## Application for Licence Amendment

Licence Number	L6498/1995/11
Licence Holder	Northern Star Resources Ltd
ACN	092 832 892
<b>File Number</b>	2012/006868-1
<b>Premises</b>	Jundee Operations SHIRE OF WILUNA WILUNA WA 6646  Mining tenements: G53/20, L53/52, L53/60, L53/68, L53/69, L53/70 - L53/73, L53/75, L53/99, L53/100, L53/102, L53/112, L53/113, L53/117, L53/136 - L53/138, L53/142, L53/143, L53/153, L53/169, L53/174, M53/155, M53/156, M53/182, M53/191, M53/192, M53/196 - M53/198, M53/199, M53/221, M53/226, M53/228 - M53/230, M53/235 - M53/237, M53/245 - M53/250, M53/326, M53/347, M53/372, M53/412 - M53/414, M53/441, M53/446, M53/451, M53/452, M53/461, M53/477 - M53/480, M53/492, M53/535 - M53/541, M53/552, M53/588, M53/589, M53/611, M53/707, M53/708, M53/711, M53/712, M53/836, M53/874, M53/895, M53/911, M53/929, M53/935, M53/940, M53/966, PL34 as depicted in Schedule 1.
<b>Date of Report</b>	30 July 2020
<b>Proposed Decision</b>	Revised licence granted

**Figure 2: Former condition W8, from Licence L6498/1995/11 as granted 21 November 2013.**

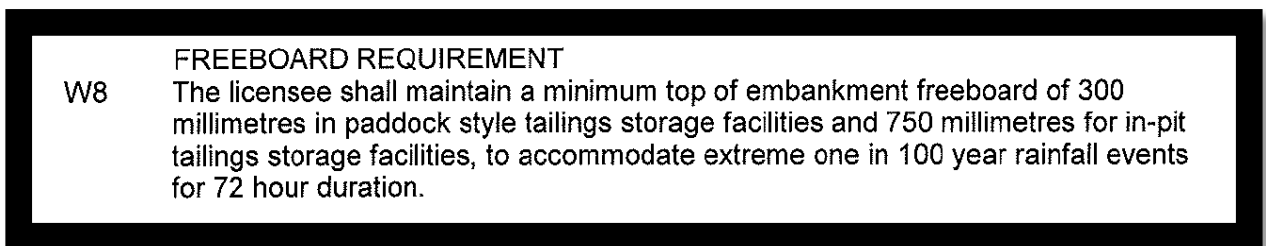
The Licence Holder has applied to 'Update Table 1.2.2 to outline an embankment operational freeboard of 300mm for TSFs as per previous licences.'

It is established that that L6498/1995/11 as granted 21 November 2013 included the standard freeboard condition shown in Figure 2.

To reduce ambiguity in the freeboard requirements, the freeboard requirements for TSF1 and 2 in Table 1.2.2 will be reworded as follows (changes highlighted):

Storage vessel or compound	Freeboard requirements
TSF 2 and TSF 1	<ul style="list-style-type: none"> <li>Minimum total vertical freeboard of 500mm or equivalent to contain a 1 in 100 year rainfall event over 72 hours (whichever is greater) from the operational pond to lowest elevation of perimeter embankment.</li> <li>Minimum vertical operational freeboard of 300mm between deposited tailings and the lowest elevation of perimeter embankment.</li> </ul>

**Figure 3: Freeboard as defined by the Department of Mines and Petroleum - Now Department of Mines, Industry Regulation and Safety (DMP, 2015)**

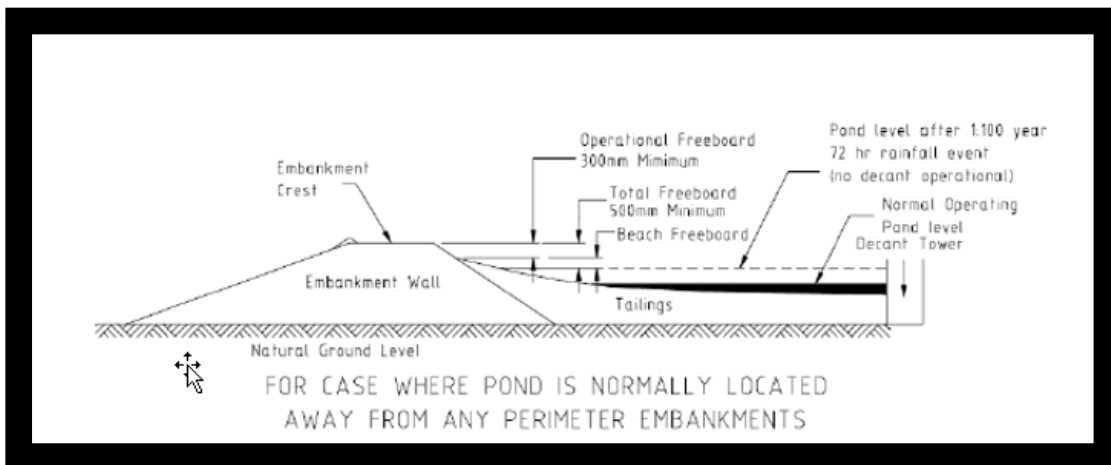
It is noted that definitions of freeboard are taken from the document 'Guide to the preparation of a design report for tailings storage facilities (TSFs)', (DMP, 2015). The existing condition specifies only a minimum total distance to the operational pond. DMP (2015) defines total freeboard as being the sum of operational freeboard and beach freeboard (refer Figure 3).
